RE: Request for Approval of Modifications to Article 401 Roosevelt Island Tidal Energy (RITE) Project Monitoring of Environmental Effects (RMEE) Plans under FERC Pilot Project License No. P-12611

ATTACHMENT: Roosevelt Island Tidal Energy Project FERC No. P-12611 Article 401 RMEE Plan Amendments (July 2019) - with Agency Consultation Log (Appendix A) and Agency Comments (Appendix B)

**ROOSEVELT ISLAND TIDAL ENERGY PROJECT
FERC No. P-12611**

Article 401 RMEE Plan Amendments

Figure RMEE-2B. DIDSON observing the TriFrame at RITE

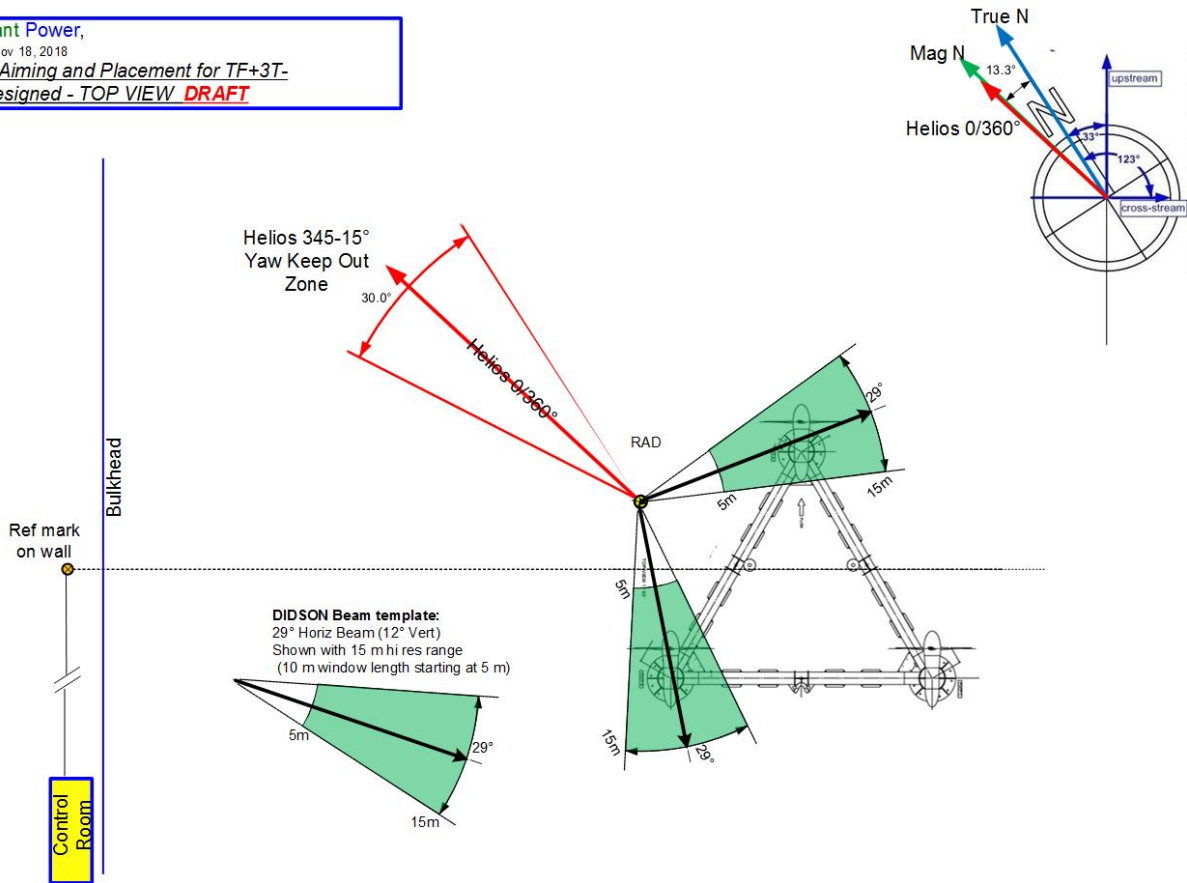
Verdant has reviewed the conclusions and recommendations of Bevelhimer et al. (2016), which are provided below. In addition, Verdant has examined a possible deployment of the DIDSON on the RAD (see Figure RMEE-2B) and determined that this configuration is unable to insonify all three turbines. Further, as discussed in the ORNL report, the turbulence generated during operation limits the effectiveness of the DIDSON in observing the TriFrame. Based on this, Verdant proposes to suspend the RMEE-2 plan during Install B-1 and instead enhance detection of tagged species under the RMEE-4 plan.

Further DIDSON data collection and analysis is unlikely to be useful during the RITE Install B-1 as the micro-scale interaction and fish impact has been shown to be de minimis. Additionally, since the biological objectives of the DIDSON observation were achieved in the 2012-2016 analysis, and the focus of the 2019 concerns is for the larger-species EFH and ESA designated fish, *Verdant proposes the suspension of the RMEE-2 Seasonal DIDSON Observation plan for Install B-1 in favor of enhanced RMEE-4 plan activities.*

Figure RMEE-3. Stationary Netting at RITE

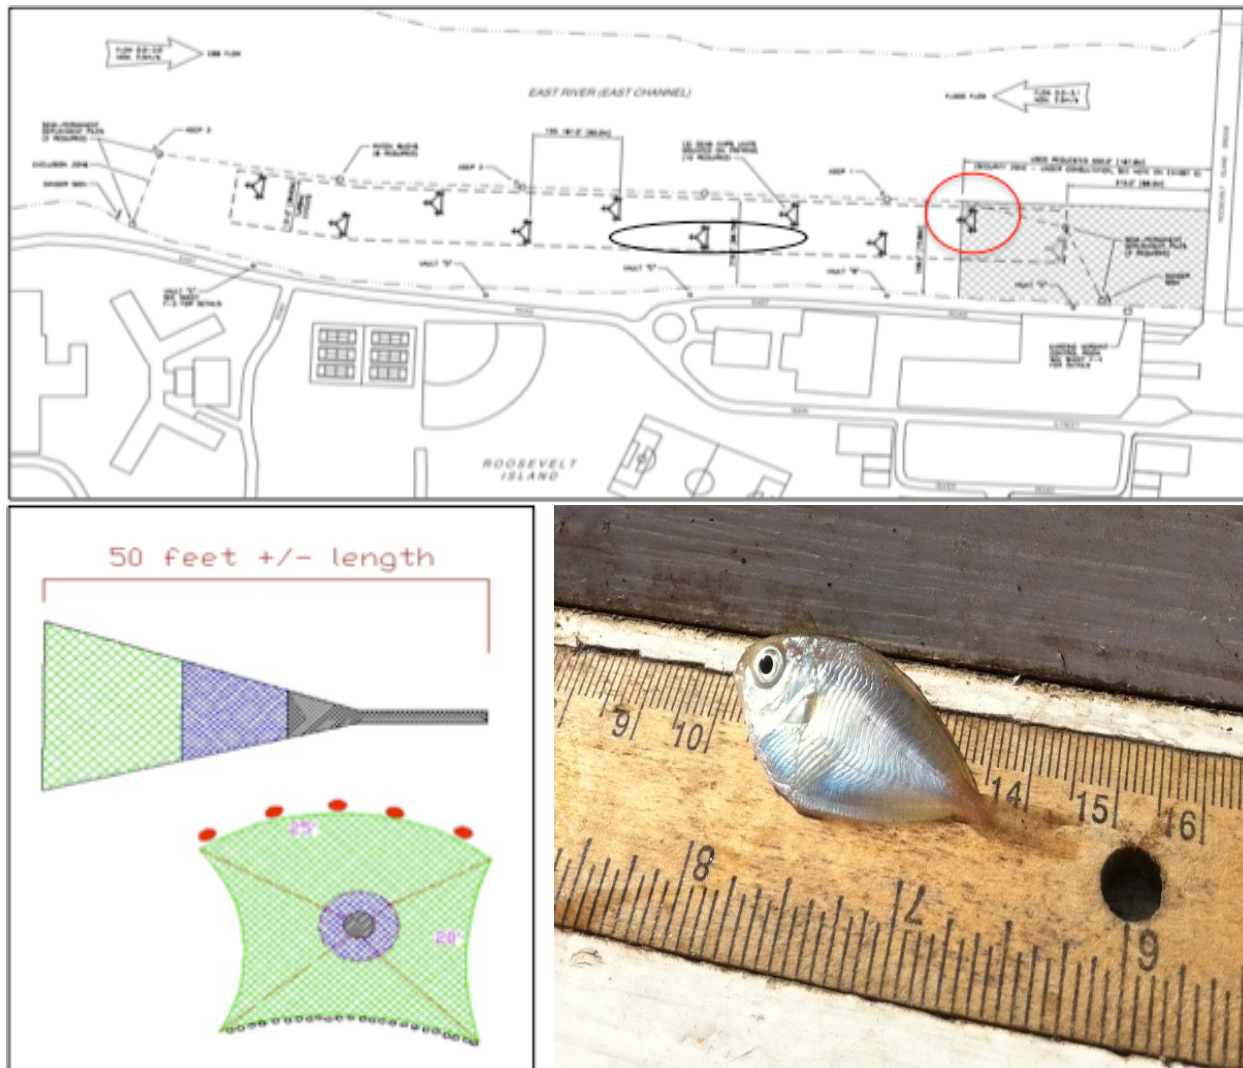
- Review of 2013 effort yielded little knowledge (2 total fish < 50mm) (see Figure RMEE-3)
- Data assemblage, including Ravenswood data, is sufficient
- Execution of netting is dangerous in close proximity to operating turbines in a high energy tidal site
- Renewal of both permits would be required

After consultation with resource agencies, Verdant provided an update on the Ravenswood impingement data that has been collected recently (2013-2015). This information (contained in Appendix A) provides a comprehensive list of the juvenile and adult fish assemblage in the east channel of the East River in the area of the RITE Project. Considering this available information and the lack of data collected via trawl netting in the project area, *Verdant proposes the suspension of RMEE-3 plan Seasonal Species Characterization Netting during Install B-1.*

Figure RMEE-4-Rev 2019. RMEE-4 Tagged Species Detection - Proposed hydrophone locations at RITE

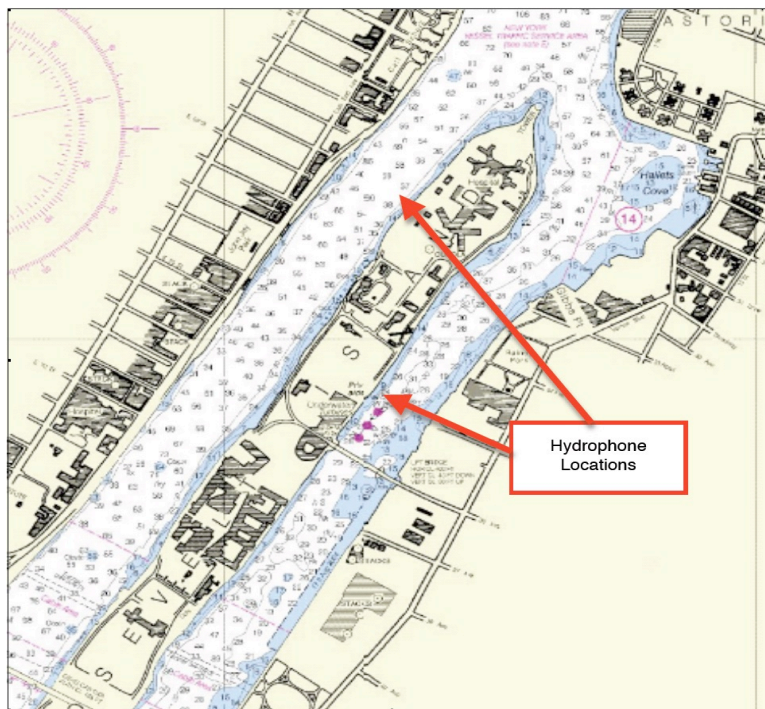
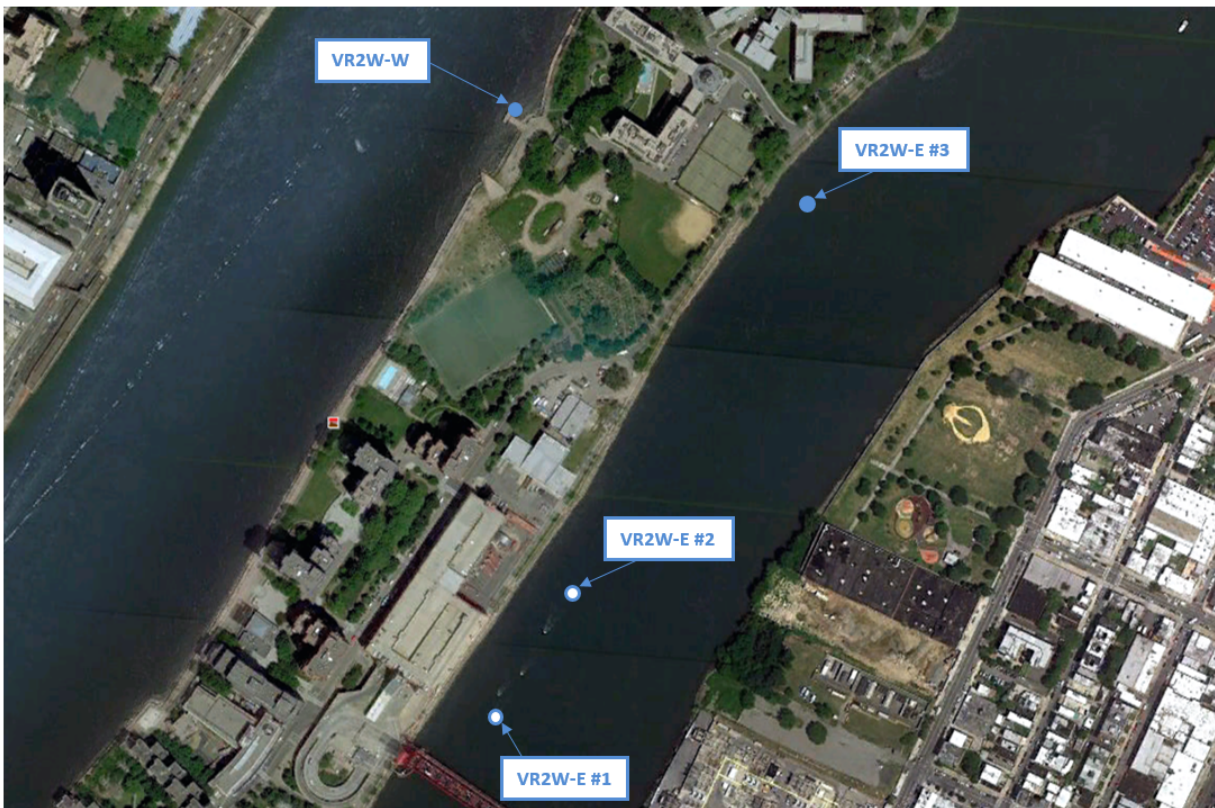
In examining options for the planned Install B-1 deployment, Verdant explored improvements to the RMEE-4 protocol. One option would be to deploy additional VEMCO receivers and tags and conduct analysis on the triangulation of detected tags to spatially locate, in 3-D, a tagged fish and its track as it passes by multiple KHPS turbines.

At a January 2019 Joint Agency Meeting, Verdant was optimistic that a RMEE-4 Triangulation concept could be implemented, however, it was later determined that the fish tags used by researchers are not compatible with this change and therefore Verdant cannot suggest such a modification to this RMEE plan.

Based on the above, Verdant will continue the multi-year VEMCO 69 kHz tag detection effort of previously tagged species in both the East and West Channels to provide input to parameters in the assessment of the risk of fish-turbine interaction at the RITE Project. In place of triangulation, Verdant proposes to deploy additional receivers in and around the RITE Project area, as an enhancement to the RMEE-4 plan (see Figure RMEE-4-Rev 2019).

In June 2019, the resource agencies provided concurrence with this enhancement of the RMEE -4 Plan during the Install B-1 effort.

Figure RMEE-6-Rev 2019. Underwater Noise Monitoring and Observation at RITE

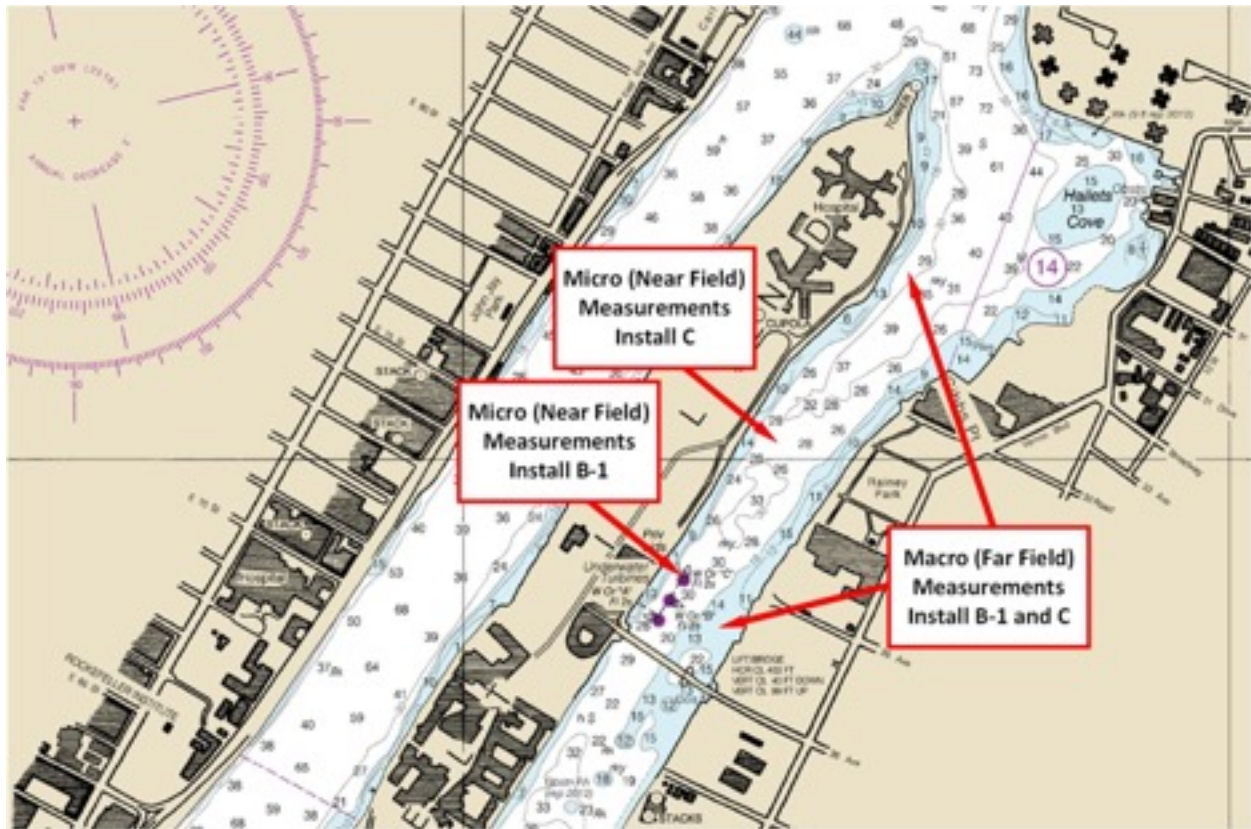
In preparing for the execution of the RMEE-6 plan during Install B-1, Verdant has developed a tentative design of a stationary hydrophone application for deployment in proximity to the Verdant TriFrame as shown in Figure RMEE-6-Rev 2019. Verdant believes this effort will allow for the answering of the fundamental questions outlined above.

The planned “Snap” Loggerhead Instruments hydrophone will be deployed 100 meters north (as recommended by IEC evolving standard for underwater noise measurements) of the TriFrame to collect 30 days of data in the presence of operating turbines utilizing a battery system.

For far-field noise analysis a similar one-week deployment at two locations as shown in Figure RMEE-6-Rev 2019 will provide far-field noise evaluation. Verdant suggests a modification to the RMEE-6 plan to two rather than 3 locations due to the recent operation of a commuter ferry (Hornblower) in the Hallets Cove location. Analysis of data will be used to answer the fundamental biologic questions.

In Verdant’s opinion, the plan as written can be executed and recommends a modification to two far-field locations based on the recent addition of a ferry terminal in Hallets Cove and the likelihood that data collected in the existing third location provides little information relative to the underwater noise of the turbines.

Therefore, Verdant proposes the modification of RMEE-6 Underwater Noise Monitoring plan during Install B-1 to two far-field locations.
